Recall Bulletin

SUBJECT: Oil Spills or Leaks onto Hot Surfaces – Modify Engine Shield

MODELS: 2011-2012 Chevrolet Cruze

2863981

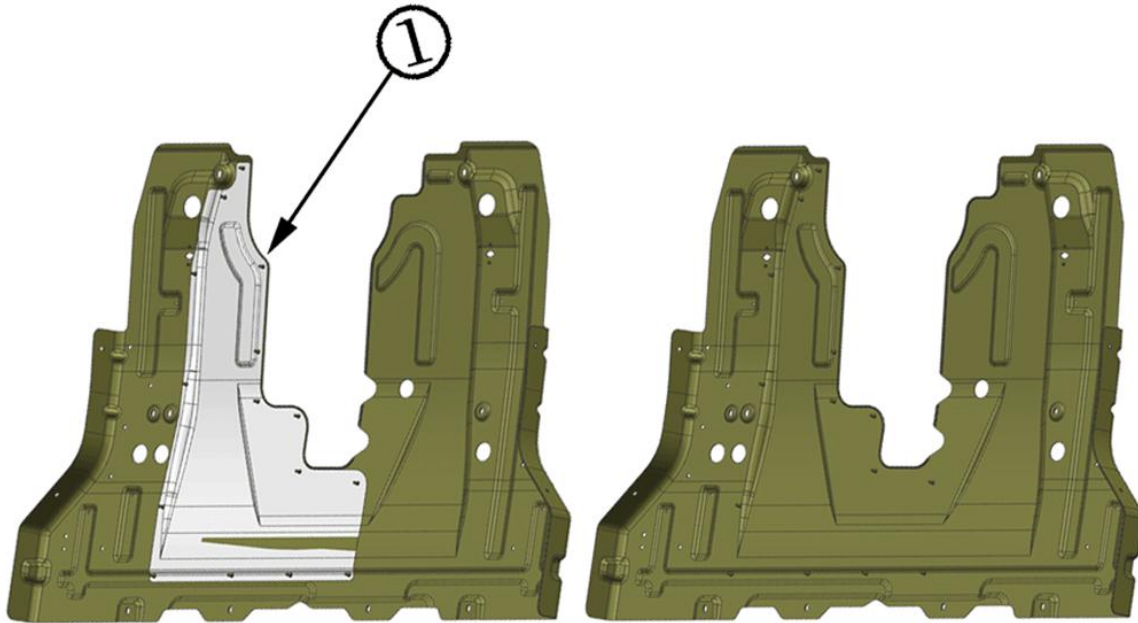
5. Locate the wire harness (7) along the driver side frame rail.
6. Remove wire harness retainers (8).

2863904

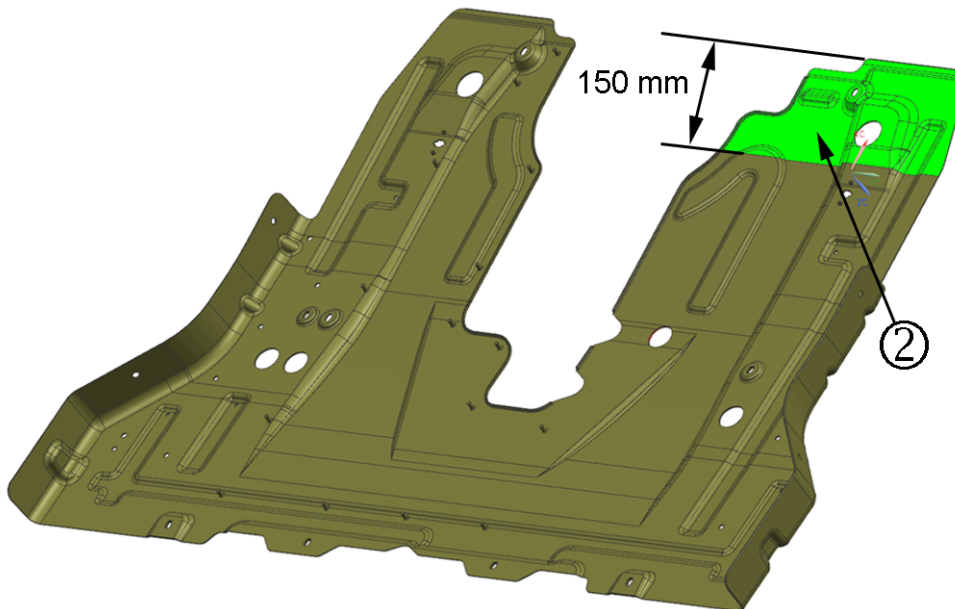
9.1 Remove the foil (1) from engine shield. Discard the foil.

2863922

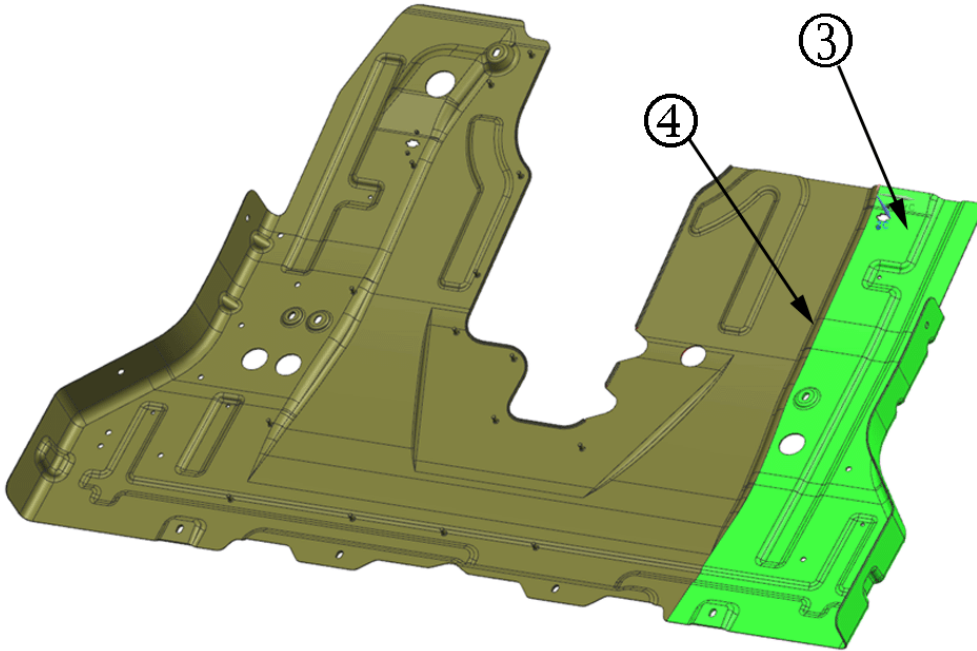
9.2 Using a Sawzall or equivalent, remove 150mm (5.9 in) from the left side of the engine shield. Refer to the light green portion (2) of the engine shield in the illustration.

2863937

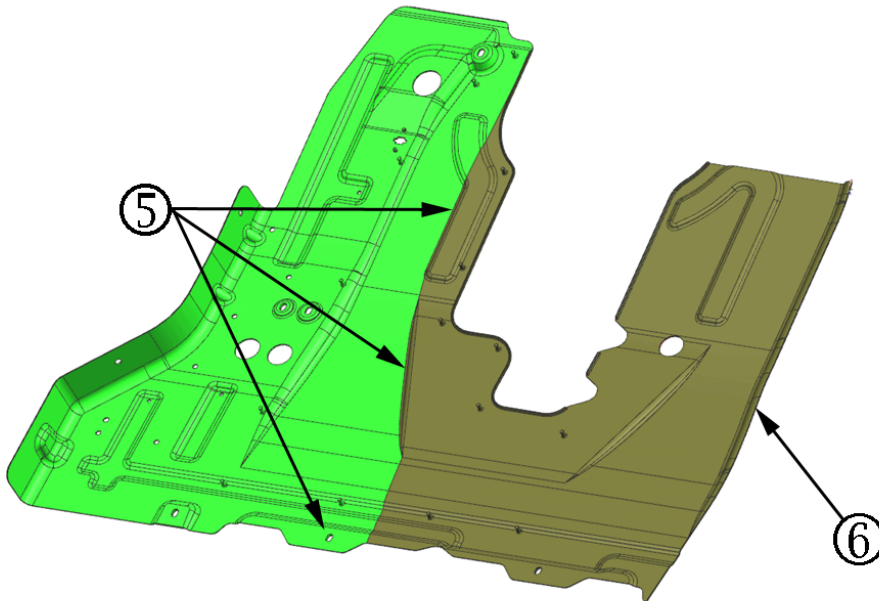
9.3 Using a Sawzall or equivalent, cut the left side of the engine shield (3). Cut the engine shield along the feature line (4) from front to rear. Refer to illustration.

2863963

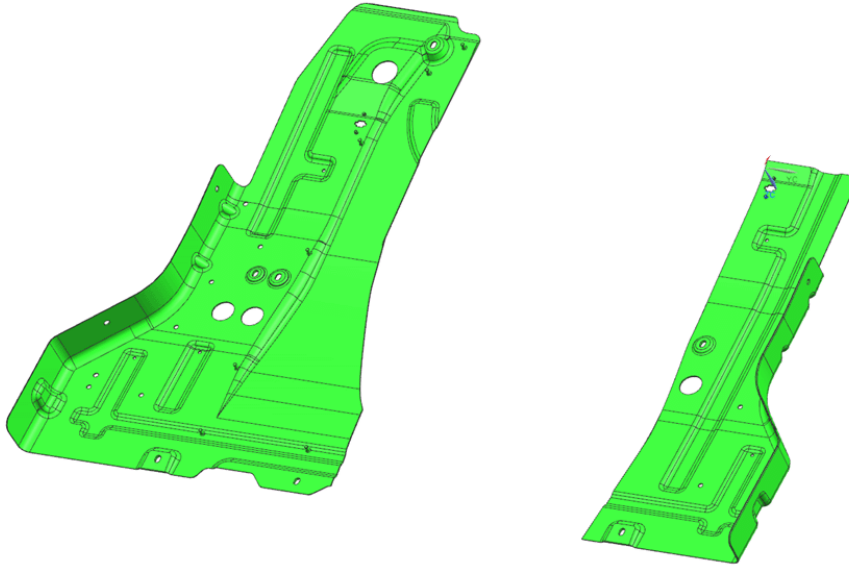
9.4 Using a Sawzall or equivalent, cut the engine shield on the right side along the two feature lines (5) then just the left of the inboard hole (5). Refer to illustration.

9.5 Discard the dark green portion of the engine shield (6).
